RNTPC Paper No. A/MOS/127
For Consideration by the
Rural and New Town Planning
Committee on 26.5.2020

APPLICATION NO. A/MOS/127

<u>Applicant</u>	Li Po Chun United World College (Hong Kong Limited) represented by Masterplan Limited
<u>Site</u>	10 Lok Wo Sha Lane, Wu Kai Sha, Sha Tin
<u>Site Area</u>	59,640 m ² (about)
<u>Lease</u>	<u>STTL 367</u> (a) New Grant No. 12365 (b) Restricted to the purposes of a non-profit-making international school and residential quarters (c) Maximum GFA: 36,300m ² (d) Maximum Site Coverage (SC): 25% (e) Maximum Building Height (BH): 42mPD
<u>Plan</u>	Approved Ma On Shan Outline Zoning Plan (OZP) No. S/MOS/22
<u>Zoning</u>	“Government, Institution or Community” (G/IC”) [a maximum BH of 42mPD]
<u>Application</u>	Proposed Minor Relaxation of BH Restriction for the Permitted School Extension Building from 42mPD to 52.4mPD

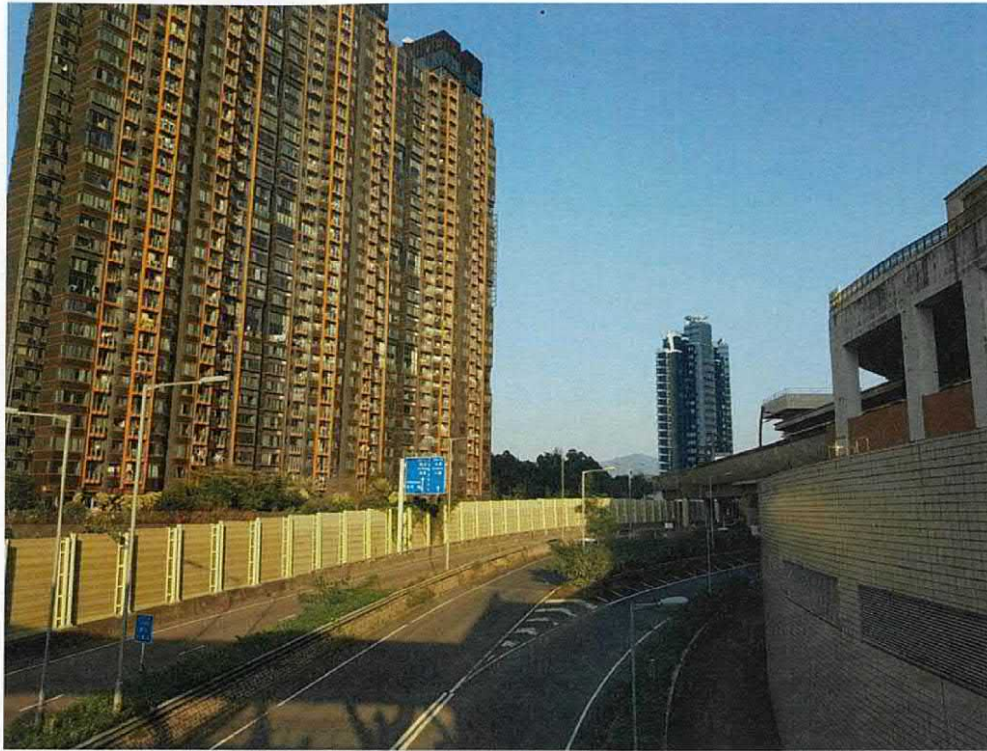
- (a) viewpoint 4 is missing in the revised figure in the R-to-C item(iii);
- (b) the applicant should clarify the discrepancy in the last sentence between the R-to-C item 5c(viii) on page 4 and the revised para. 7.2 in Annex B; and
- (c) only the evaluation of visual impact without mitigation measures is provided in para. 7.2. The applicant should provide the overall visual impact and photomontages with mitigation measures, such as choice of materials with suitable colours and provisions of plantings, etc.
